Re: RCRA Corrective Action Administrative Order on Consent (AOC) Pilot Perimeter Groundwater Collection Trench Construction Certification Report GM GPS - Bedford Facility, IND 006036099, Docket No. RCRA 05-2014-0011 Bedford, Indiana

Construction Certification Report

Pilot Perimeter Groundwater Trench Collection System

ND 3 C-09	20'-0"	INSTALL #53 STONE UNDERLAIN WITH GEOTEXTILE IN LIEU OF 6" OF TOPSOIL
		ACTED NATIVE BACKFILL

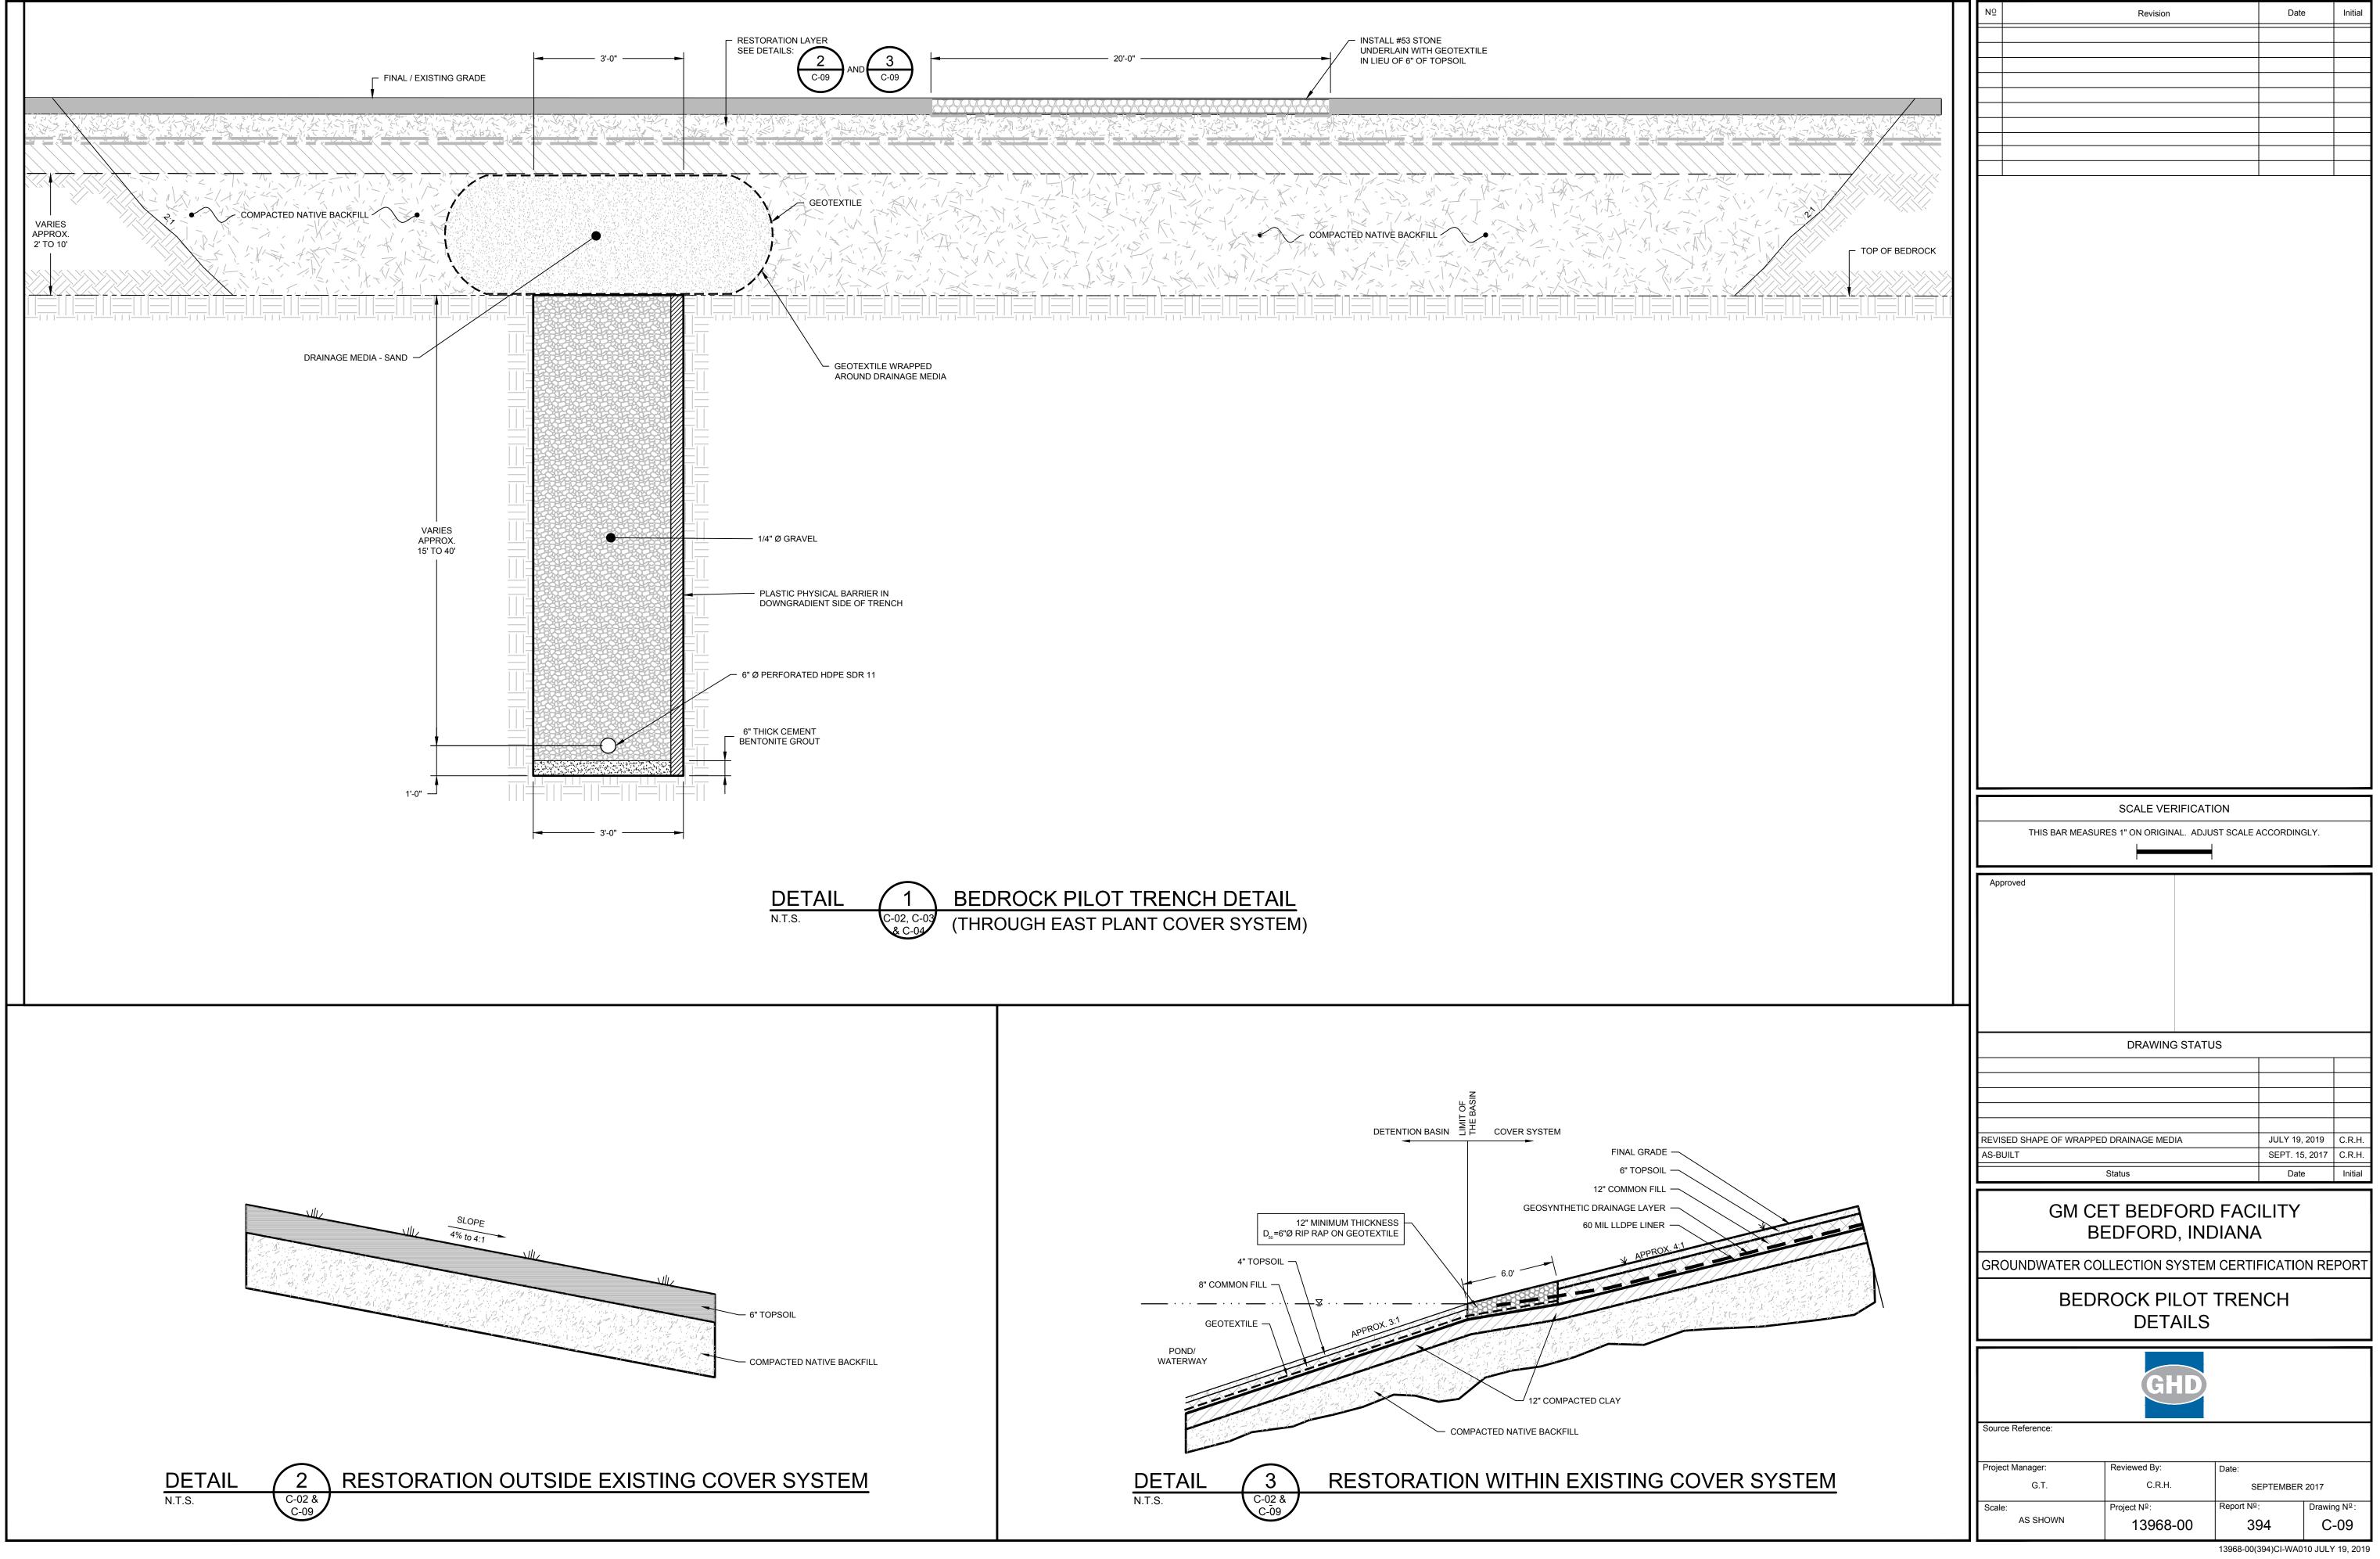
- b. Agreed. The reference to as-built details regarding the drainage media sand placement being presented on Drawing C-04 is incorrect. The drainage sand media placement over the top of the Bedrock Pilot Trench is shown on Drawing C-09, as suggested. The text within Section 3.4.7 of the CCR will be appropriately corrected. Furthermore, the references on Drawing C-03 to Drawings C-01A and C-01B will be revised to correctly reference Drawings C-04 and C-05.
- c. Agreed. The reference to Drawing C-05 for the liner installation panel layout, including destructive seam test and seam repair locations, will be corrected to Drawing C-08.

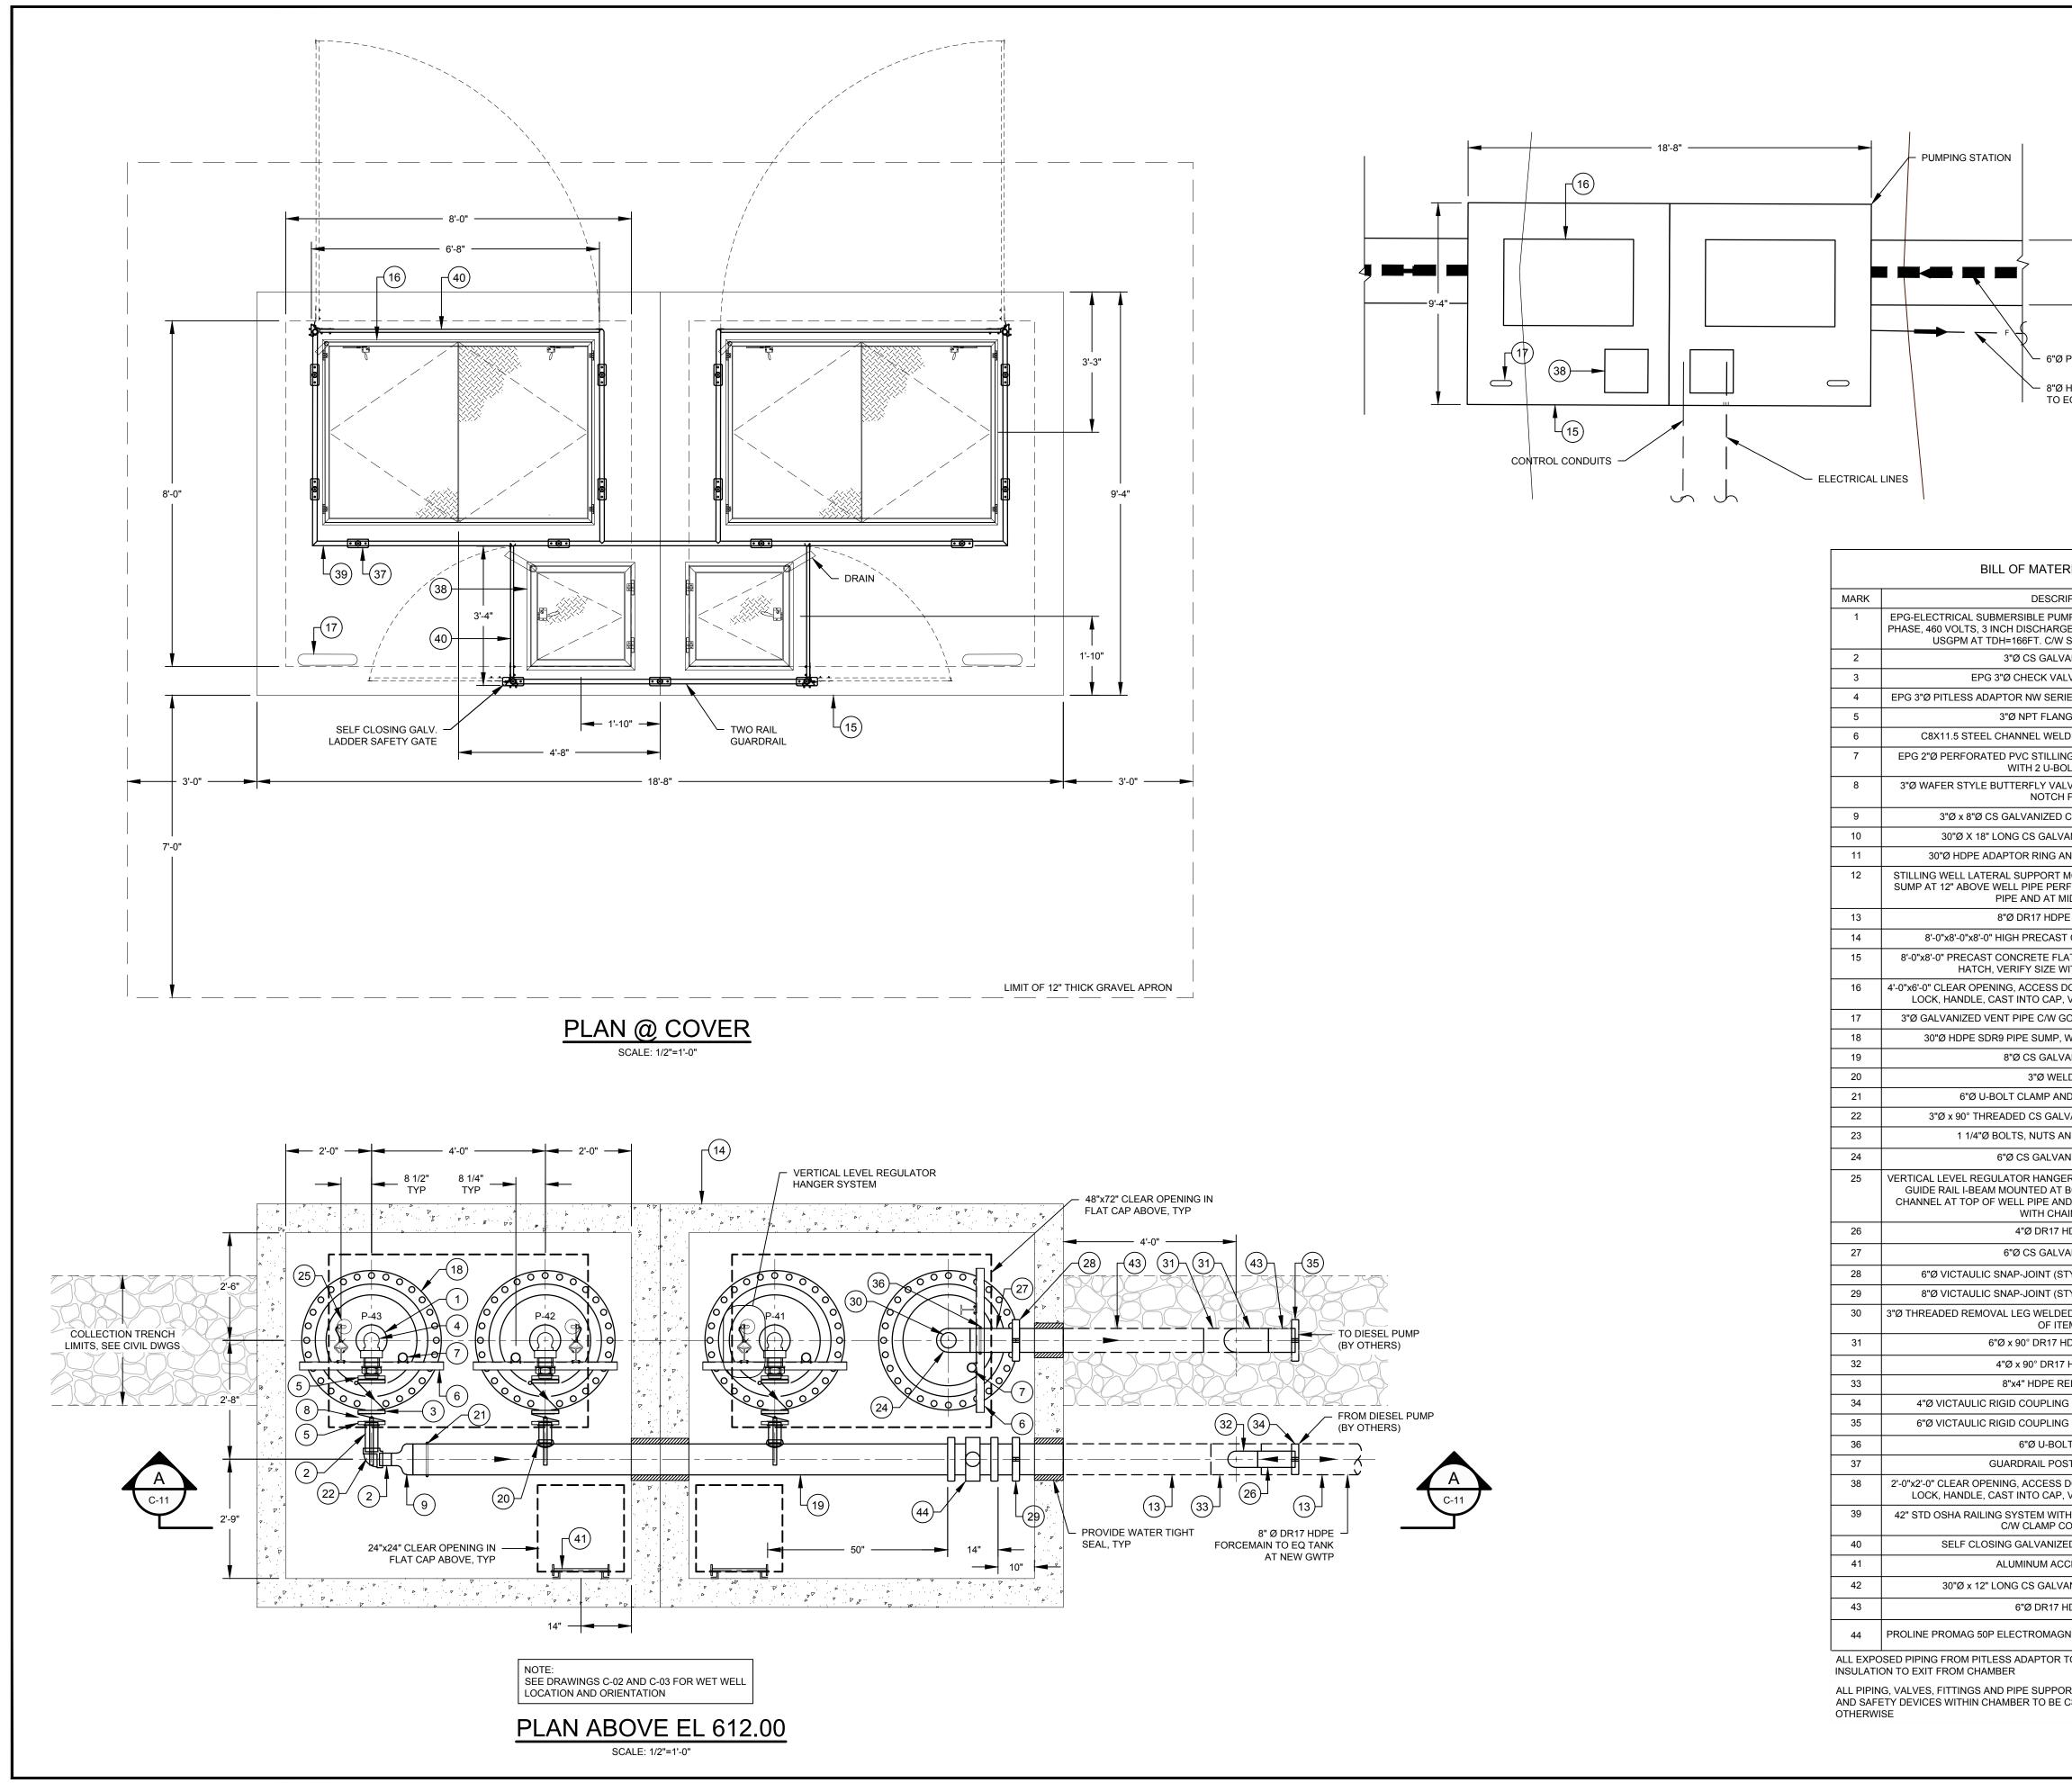
- a. Section 3.4.4, Wet Well Chamber (WW#4), indicates as-built details of the WW#4 sumps and chamber construction are presented on Drawing C-06; however, this detail is not provided on Drawing C-6 and while Drawing C-8 has a WW#4 drawing, it has minimal details.
- b. Section 3.4.7, Drainage Media Sand, indicates details are provided on Drawing C-04; however, these details appear missing and the correct reference may be Drawing C-09. In addition Drawing C-04 references Drawing C-01B, which was not included.
- c. Section 3.4.9.2, Linear Low Density Polyethylene Liner, references Drawing C-05 in the last sentence of this section; however, the correct reference appears to be Drawing C-08.

a. Agreed. The reference to as-built details for the WW#4 sumps and chamber construction being presented on Drawing C-06 is incorrect. In fact, the WW#4 details are not currently shown on any of the as-built drawings, as the chamber was largely constructed in accordance with the design. The location of the WW#4 chamber was surveyed and the as-built location is shown on the drawings, including the field adjustment where the space between the two chambers was filled with additional concrete. To complete the as-built drawings, the original chamber design layout will be added to the as-builts, although it should be noted that the internal piping was not surveyed within the WW#4 chamber as to the exact positioning within the chamber, but it closely replicates the original design. During installation of the equipment and instrumentation within the WW#4 sump, the elevation settings for the pumps and alarms were set to the design elevations.
